# Access Compliance Report

### (Curb Ramps)

Intersection ID: 49320	Main Street: TAVISTOCK_CT	Cross Street: HUNTERS_MOON_LN	Location: NW
ADA ID: A20D09417FE5	Ramp Type: PerpDiag	Initial Pass/Fail: Fail	Overall Compliance: No
			Severity Score: 21.25

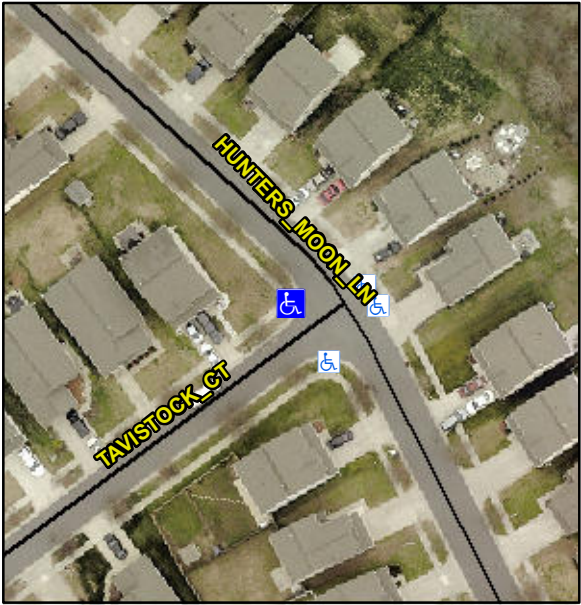
Codes/Mitigation Info/Possible Solution			Field Measurements/Component Compliance		
	Possible Solutions:		<b>Compliance</b>	<b>Description</b>	<b>Data</b>
	<b>Remove &amp; Replace Curb Ramp With Two New Directional Ramps or Equivalent.</b>		<b>Yes</b>	Ramp Length (in)	70.0
			<b>No</b>	Ramp Width (in)	46.0
			<b>N/A</b>	Flare Type LT	N/A
			<b>N/A</b>	Flare Slope LT (%)	N/A
			<b>N/A</b>	Flare Traversable LT?	N/A
			<b>N/A</b>	Landing Length (in)	N/A
			<b>N/A</b>	Landing Width (in)	N/A
			<b>N/A</b>	Landing Slope (%)	N/A
			<b>N/A</b>	Landing X Slope (%)	N/A
			<b>N/A</b>	Landing Curb? (Y/N)	N/A
			<b>N/A</b>	Shared Landing?	N/A
			<b>N/A</b>	Gutter Ponding?	N/A
			<b>N/A</b>	Gutter Lip Ht (in)	N/A
			<b>No</b>	Painted X Walk1?	N/A
				X Walk 1 Direction	To SE
			<b>N/A</b>	X Walk 1 Width (in)	N/A
				X Walk 1 Slope (%)	5.1
				X Walk 1 X Slope (%)	0.9
			<b>N/A</b>	Ramp inside XWalk1?	N/A
<p>Surveyor Notes:</p> <p><b>N/A</b></p> <p>PROW/ADA:</p> <p><b>R304.5.1, R304.5.3</b></p>			<b>N/A</b>	Flare Type RT	N/A

<b>N/A</b>	Flare Slope RT (%)	N/A
			<b>N/A</b>	Flare Traversable RT?	N/A
			<b>N/A</b>	DWS Provided?	N/A
			<b>N/A</b>	DWS Contrast?	N/A
			<b>N/A</b>	DWS Length (in)	N/A
			<b>N/A</b>	DWS Full Width?	N/A
			<b>N/A</b>	DWS Offset (in)	N/A
			<b>N/A</b>	Gutter Slope (%)	N/A
			<b>N/A</b>	Gutter X Slope (%)	N/A
			<b>No</b>	Painted X Walk2?	N/A
				X Walk 2 Direction	To NE
			<b>N/A</b>	X Walk 2 Width (in)	N/A
				X Walk 2 Slope (%)	1.7
				X Walk 2 X Slope (%)	6.1
			<b>N/A</b>	Ramp inside XWalk2?	N/A
			<b>N/A</b>	Clear Space?	N/A
			<b>N/A</b>	Clear Space to XWalk (in)	N/A
			<b>N/A</b>	Storm Grate/Utility Hazard?	N/A
				Storm Grate/Utility Type	N/A
<p>Total Cost:</p> <p>\$ 3200.00</p>			<b>N/A</b>		N/A
			<b>Yes</b>	Surface Condition? (G/P)	Good
